SERVICE BULLETIN M20-291A

Date: August 18, 2006

SUBJECT: S-TEC Autopilot/Full Flap Condition

MODELS/ SN  
AFFECTED:M20M - All aircraft equipped with Garmin G1000 Integrated Avionics and S-TEC Autopilot  
M20R - Aircraft equipped with Garmin G1000 Integrated Avionics and S-TEC Autopilot, S/N  
29-0455 and prior

Figure SB M20-291-1

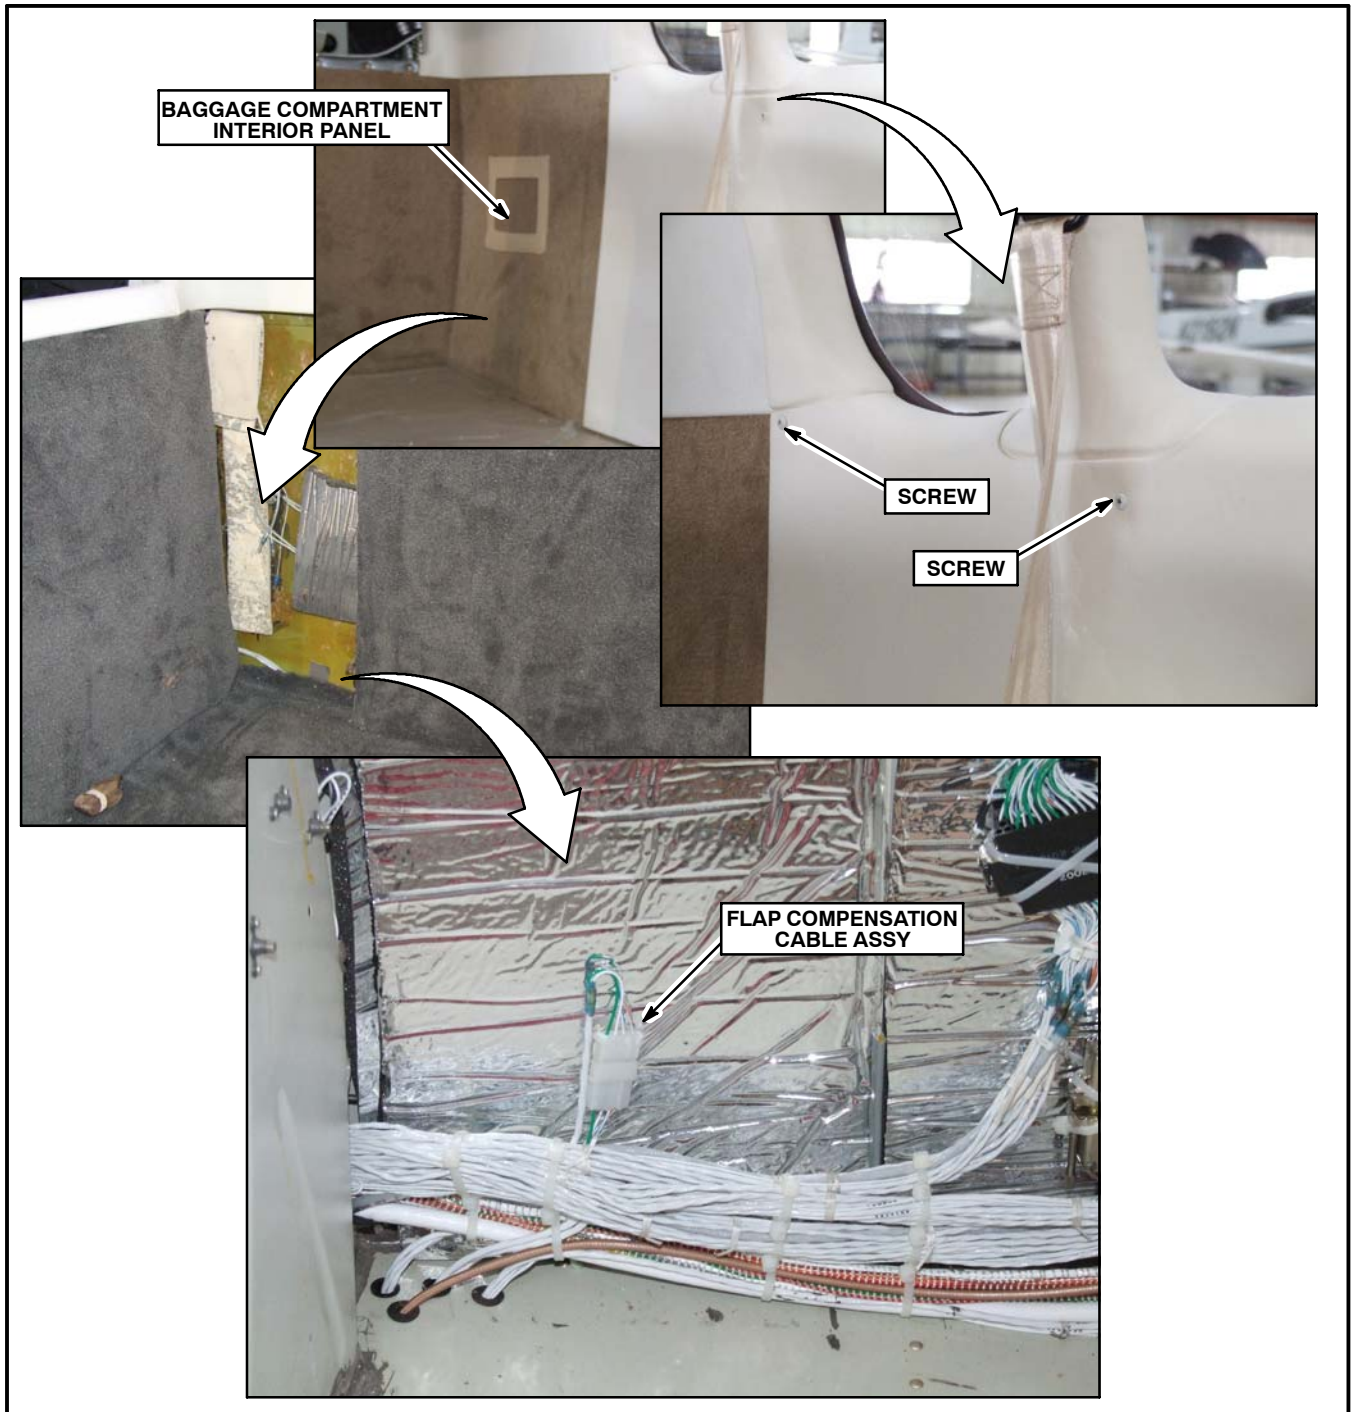
1. Turn master switch - OFF.
2. Locate and remove two screws securing baggage compartment left side interior panels (Ref. Figure M20-291-001). Carefully, so as not to permanently crease the panel, pull the panel away from fuselage structure enough to allow the pushing/sliding of the panel forward to expose the harness where the Flap Compensation Cable Assembly connector is located.

Figure SB M20-291-2

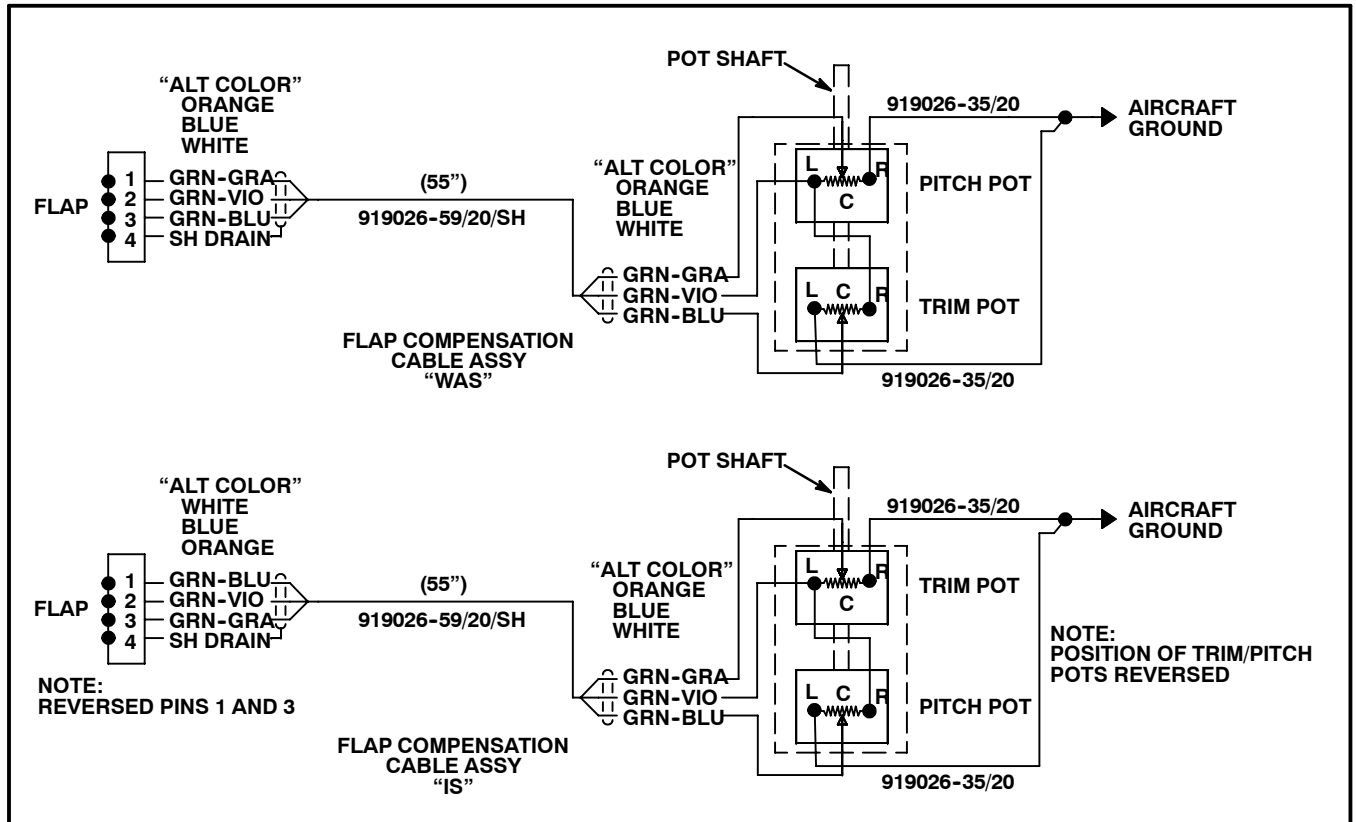
INTRODUCTION: Aircraft equipped with Garmin G1000 and S-TEC autopilot will experience a hard nose down pitch condition with the flaps in full down position and the autopilot engaged. This condition is corrected by reversing position of two wires in the Flap Compensation Cable Assembly supplying the Pitch Pot and Trim Pot. By reversing the wires, the Trim Pot and Pitch Pot functions are reversed.

3. Disconnect the connector.
4. On the male side of the connector, locate pins 1 and 3 (Ref. Figure M20-291-002). Depress the tabs on the pins to allow their removal from the connector housing. Relocate pin 1 (GRN-GRA) into pin 3 location. Relocate pin 3 (GRN-BLU) into pin 1 location.
